UNITED STATES PATENT AND TRADEMARK OFFICE

Office Action Summary

09/942,586

Detailed Action

And Figures 6a and 6b below;

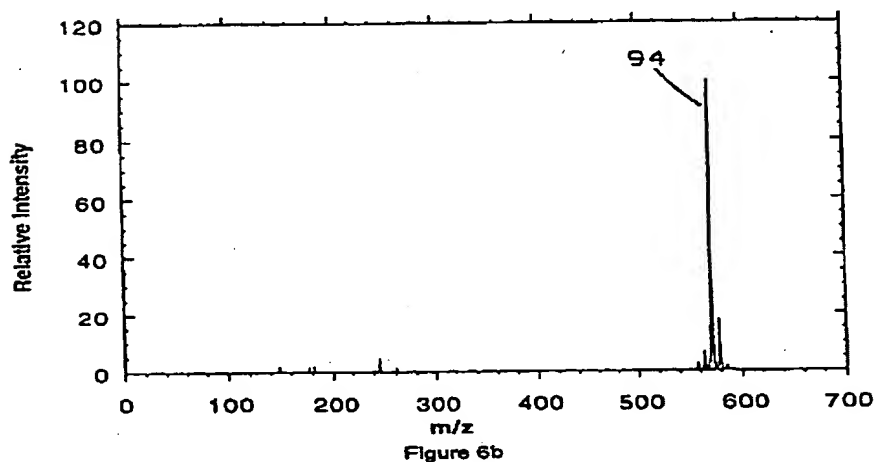
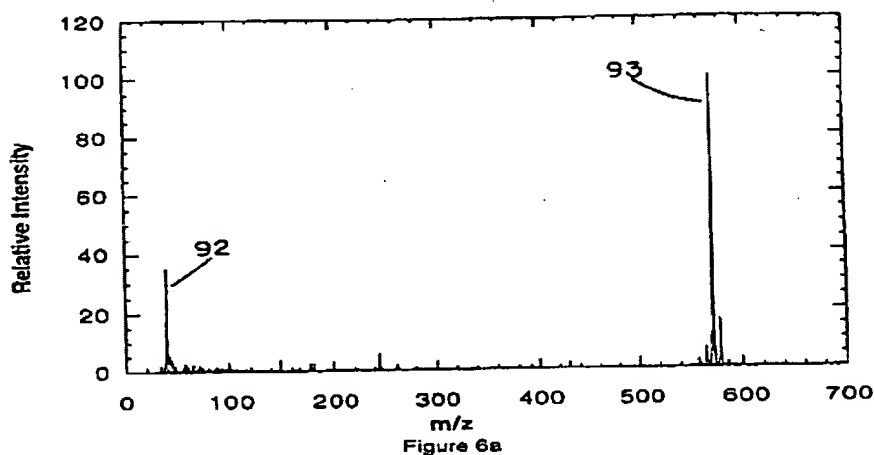
In FIG. 6a the hexapole 40 q_3 value is set to transmit a wide m/z range and an impurity potassium peak 92 and the protonated doubly charged Gramicidin S peak 93 ($M+2H$)²⁺ are observed in the mass spectrum. FIG. 6b is a mass spectrum of the same Gramicidin S solution Electrosprayed using identical conditions as in FIG. 6a but with the hexapole 40 q_3 value is set so that a low m/z cutoff occurs. The potassium ions are no longer transmitted to the mass analyzer but the ion transmission efficiency of the doubly charged Gramicidin S ions as shown by peak 94, is still retained.

The examiner has interpreted from the Whitehouse (066) references above that Whitehouse (066) varies the energy range of interest and the lens voltage of the ion guide to optimize the transmission of groups of ions having m/z (thus the charge state) values of interest, out of the ion guide for mass analysis. Whitehouse (066) clearly understands that, utilizing the combination of applied frequency and the exit lens voltage ramp as an energy/charge discriminator (energy barrier), specific ranges of m/z can be selected for transmission or retention, thereby improving spectral resolution (separation), which is equivalent to the applicants claimed invention.
